## ORIGINATION FORM

Proposed Revisions to a Standard Plans Index  
(Please provide all information — Incomplete forms will be returned)

Index Number: 649-031

Index Title: Mast Arm Assemblies

**ELEVATION AND NOTES**

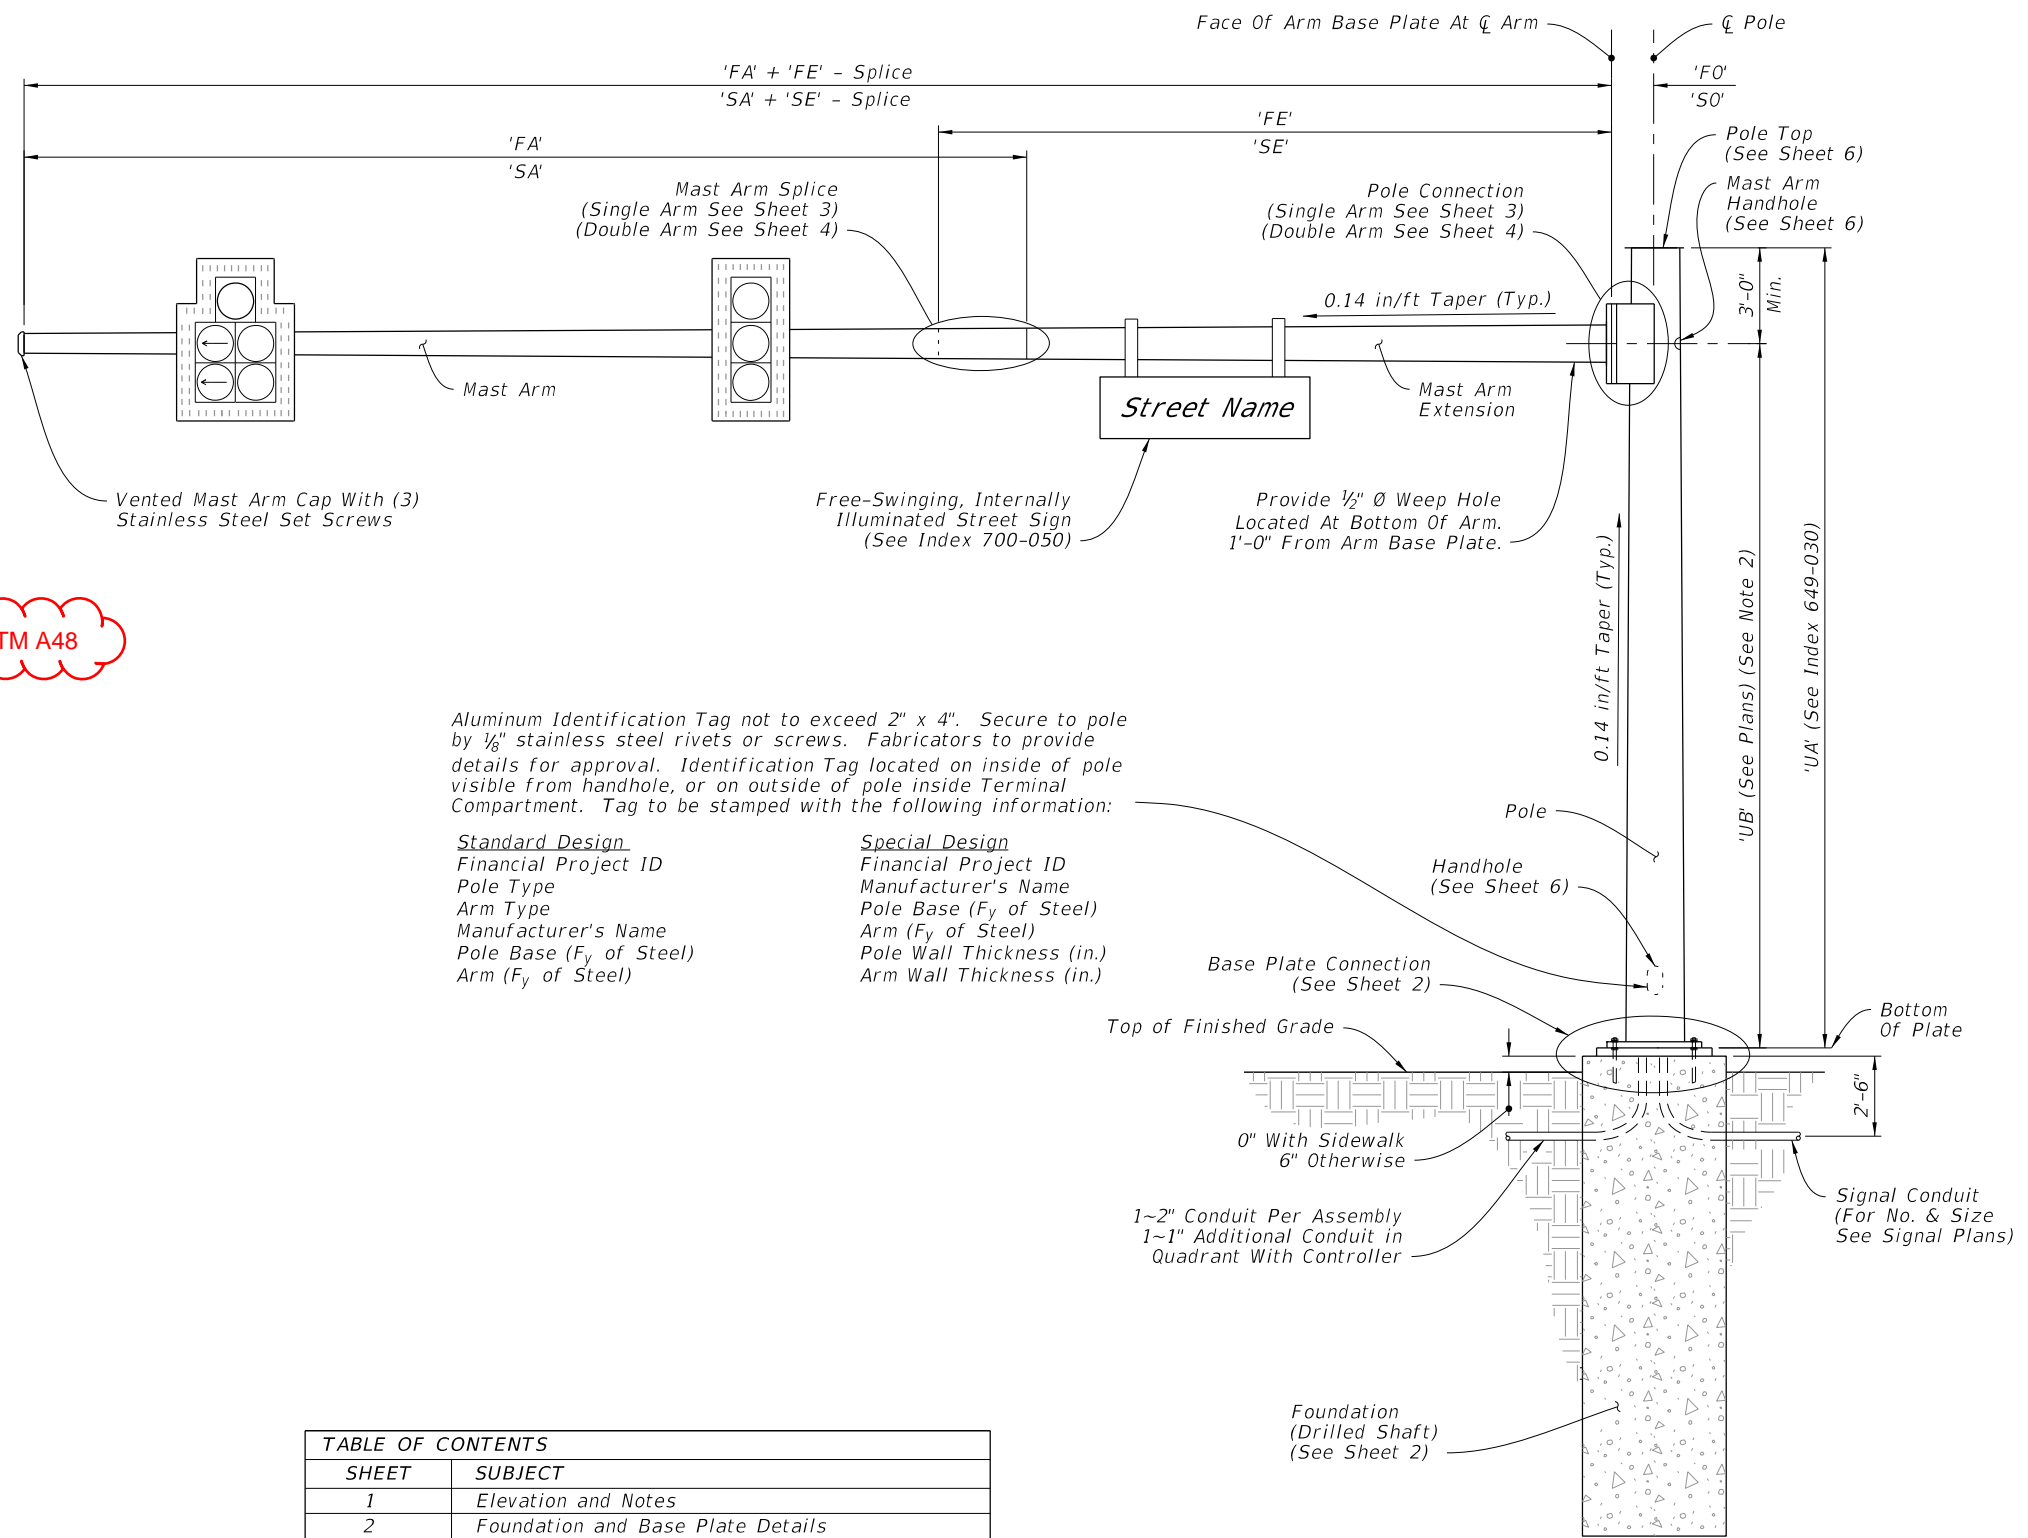
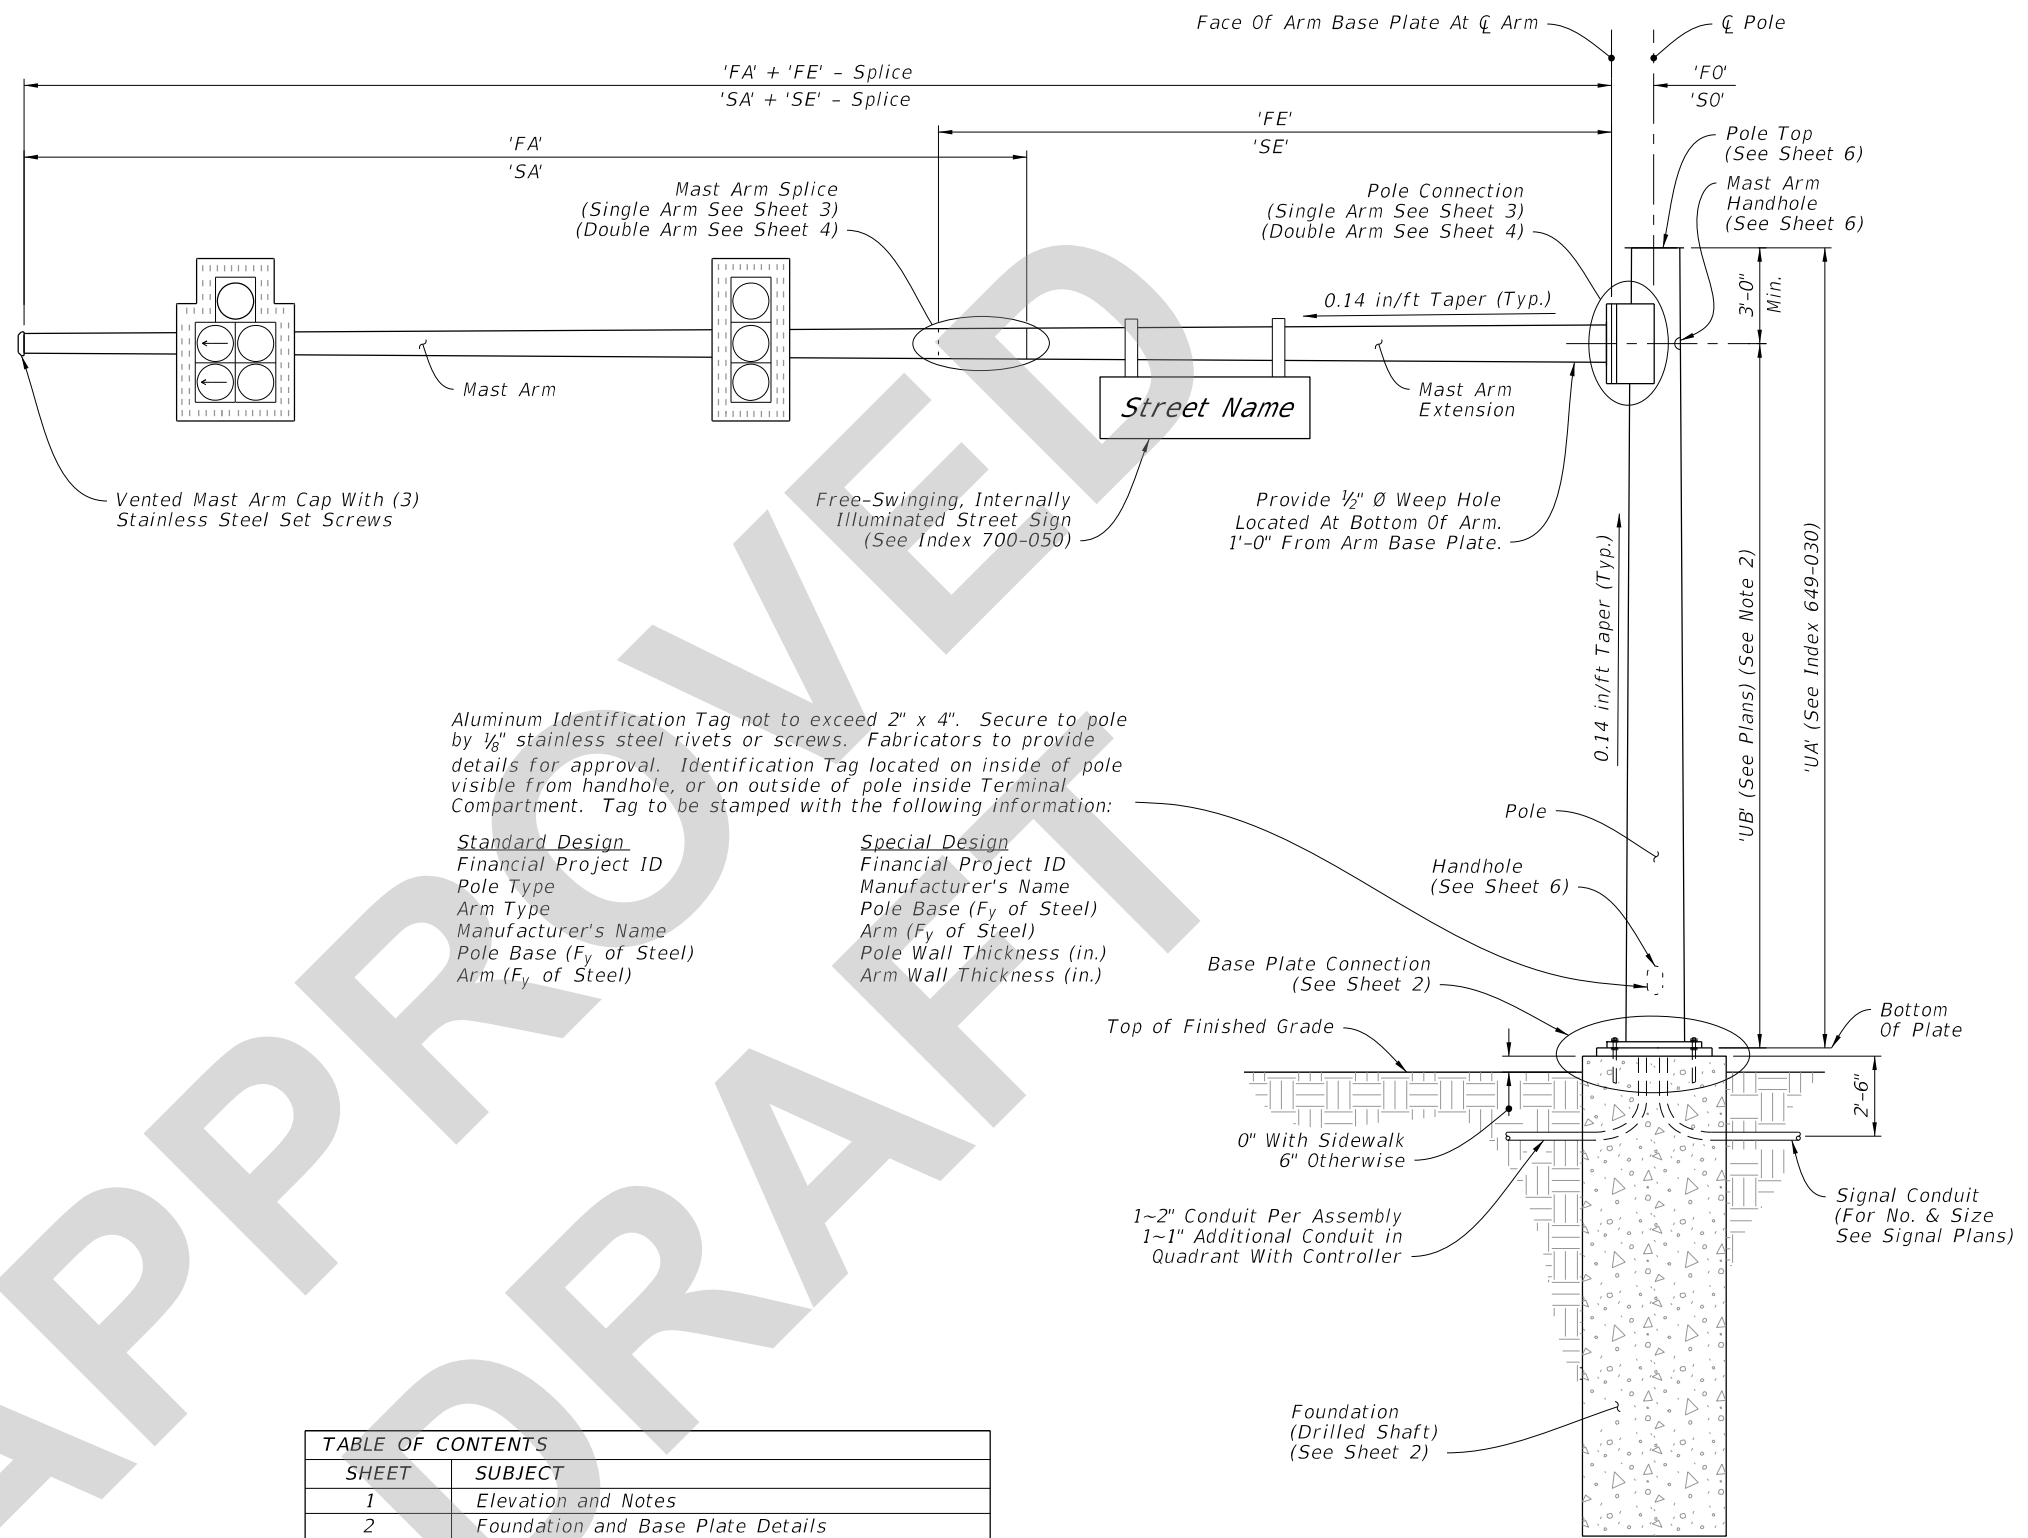
Sheet 1: Note 4I added optional other materials.

- Handhole Cover: ASTM A1011 Grade 50, 55, 60 or 65
  - Aluminum Pole Caps and Nut Covers: ASTM B26 (319-F), **ASTM A1011 or ASTM A48**
  - Stainless Steel Screws: AISI Type 316

- Handhole Cover: ASTM A1011 Grade 50, 55, 60 or 65
  - Pole Caps and Nut Covers: Fabricate from cast aluminum or galvanized carbon steel.
  - Stainless Steel Screws: AISI Type 316

FOUNDATION AND BASE PLATE DETAILS

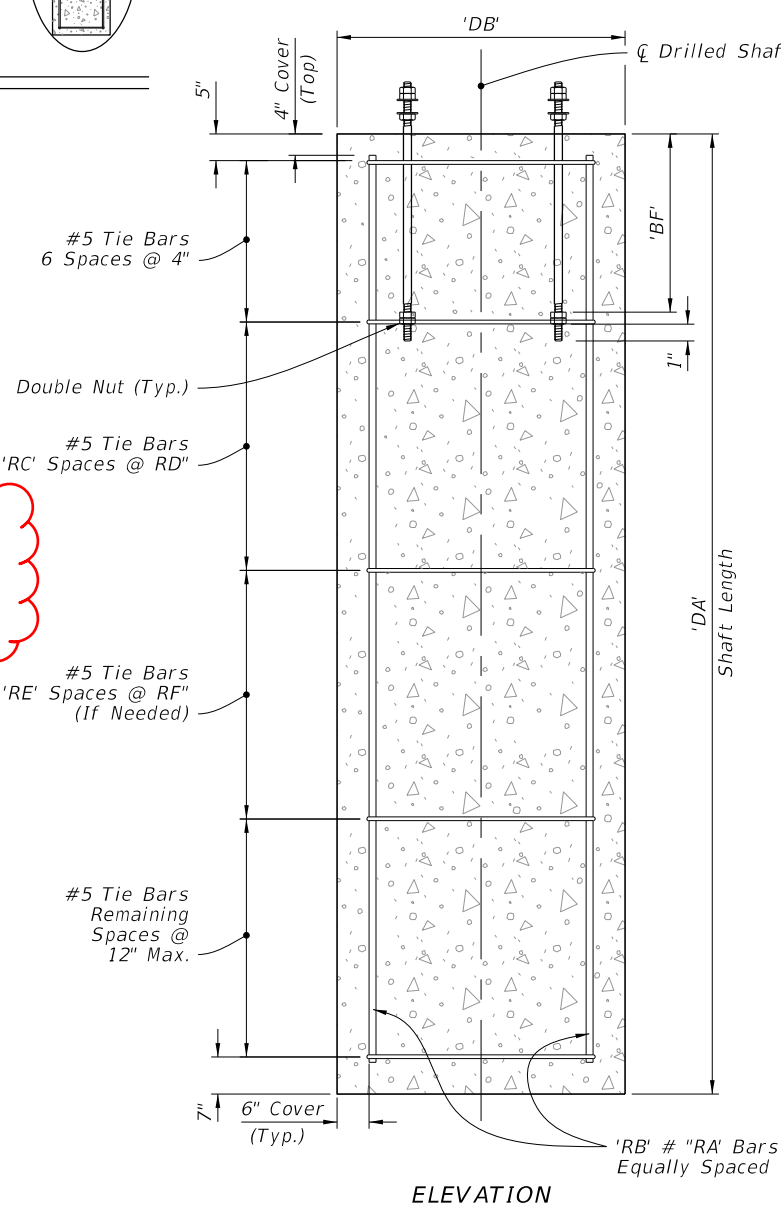
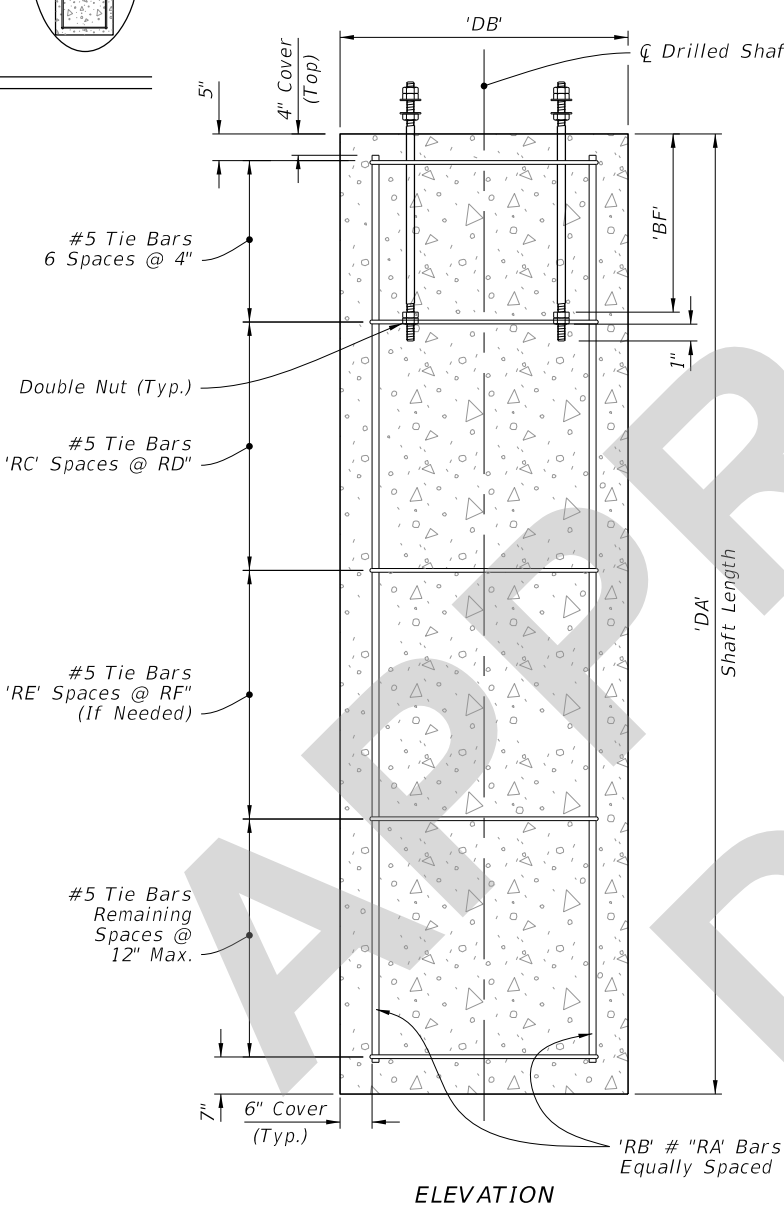
Sheet 2: Added Note 4.

4. Detail 'A' Silicone Caulk may be applied after installation. Consult with Manufacturer

ARM SPLICE

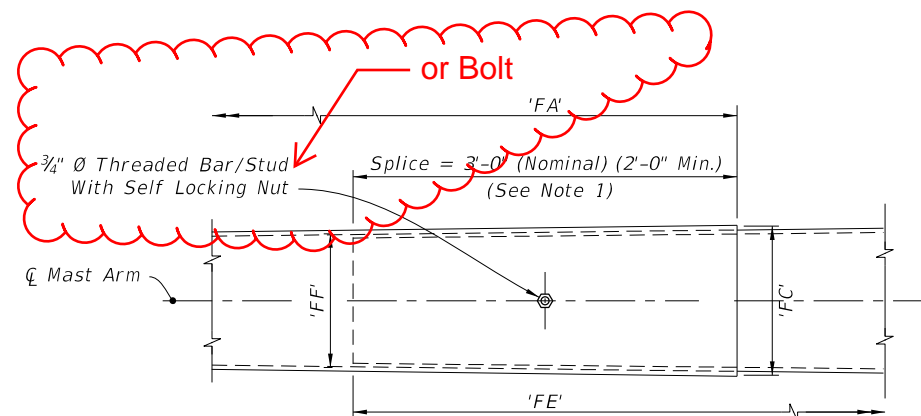
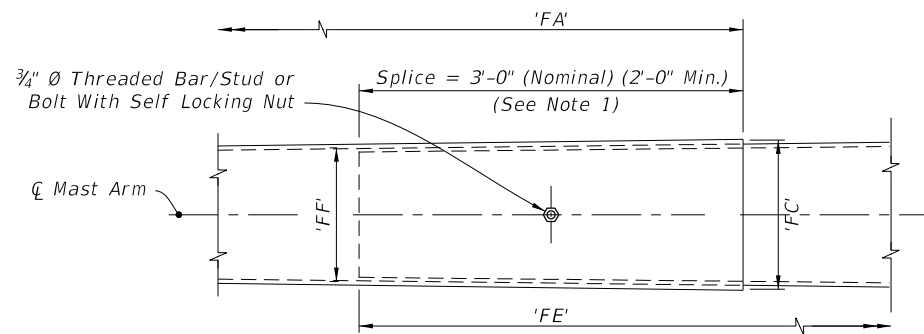
Sheet 3 & 4: Added bolt as option for splice connection.

POLE TOP

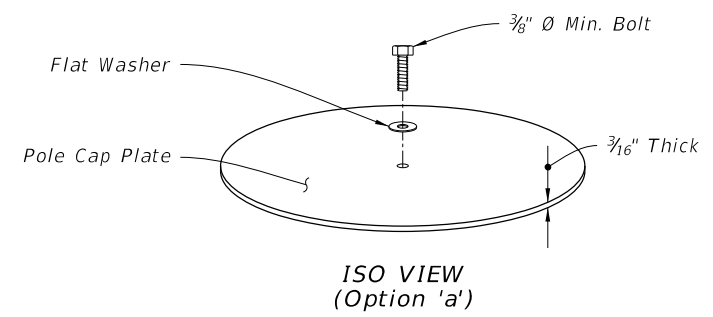
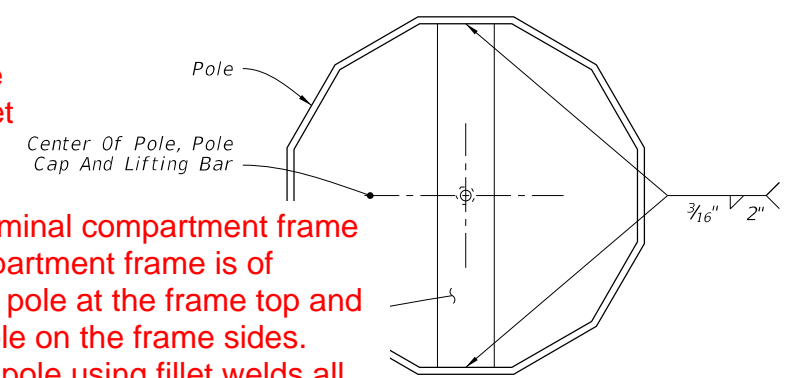
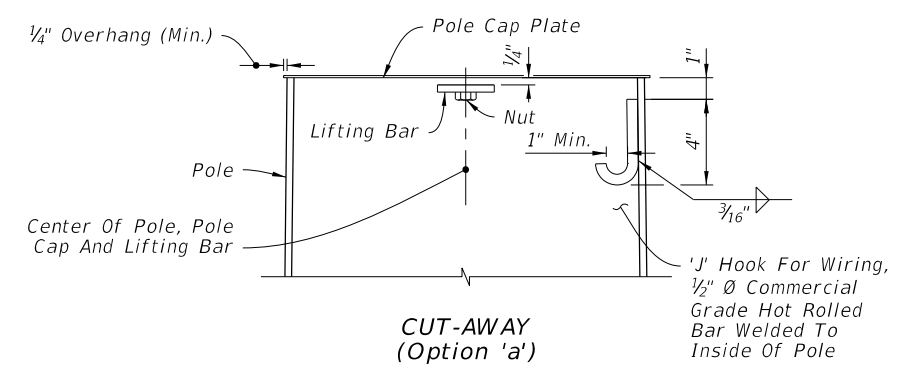
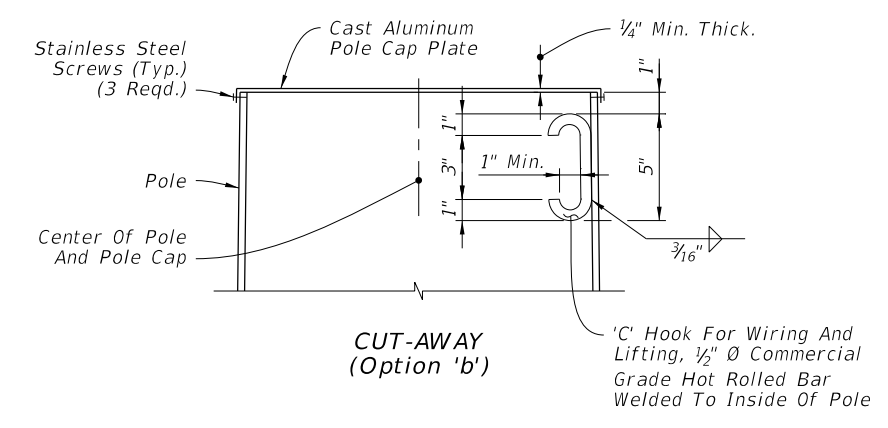
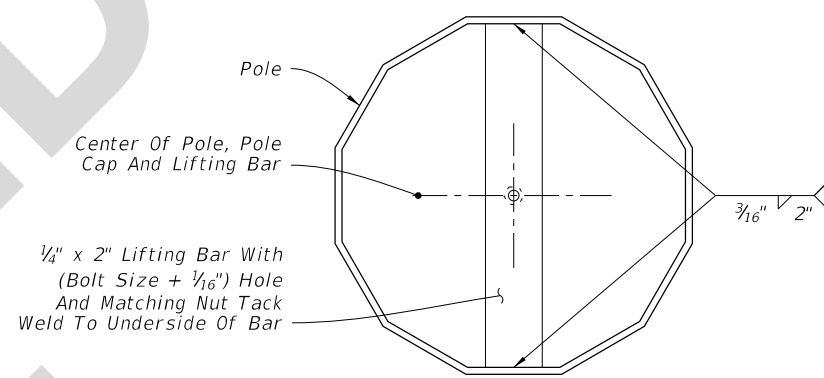
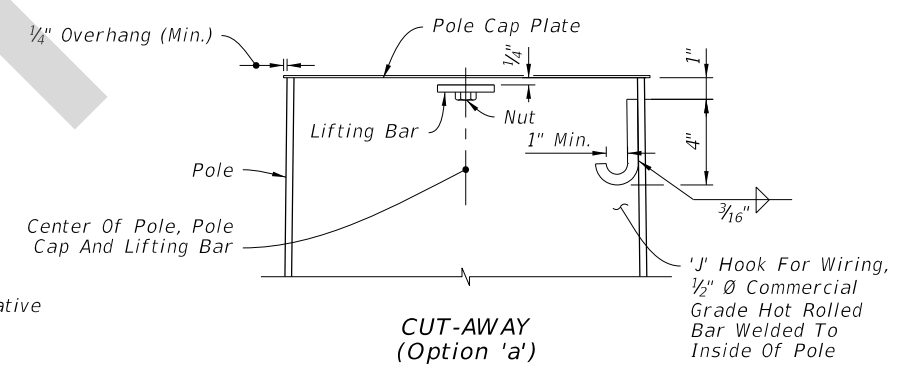
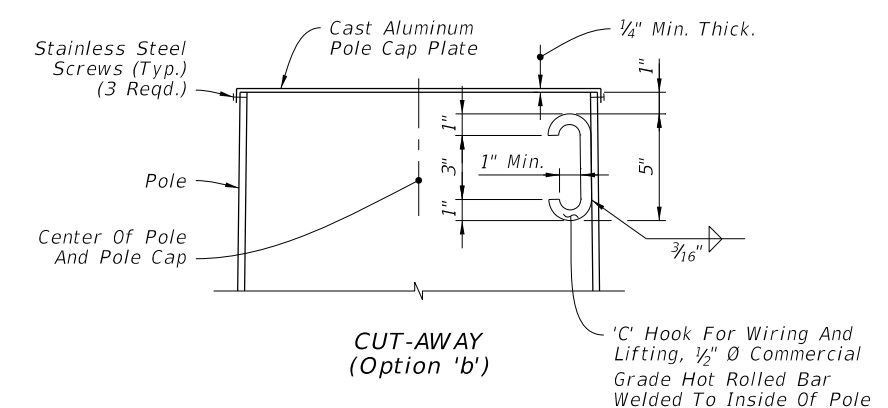
Sheet 6: Clarified that a domed shape top cap is permissible.

5. **ADDED to Note 4:** Cap may be flat plate or domed cap with set screws.

**ADDED Note 5:** An alternate terminal compartment frame detail is allowed where the compartment frame is of constant depth and cuts into the pole at the frame top and bottom but lays flush with the pole on the frame sides. The frame is then welded to the pole using fillet welds all around the outside.
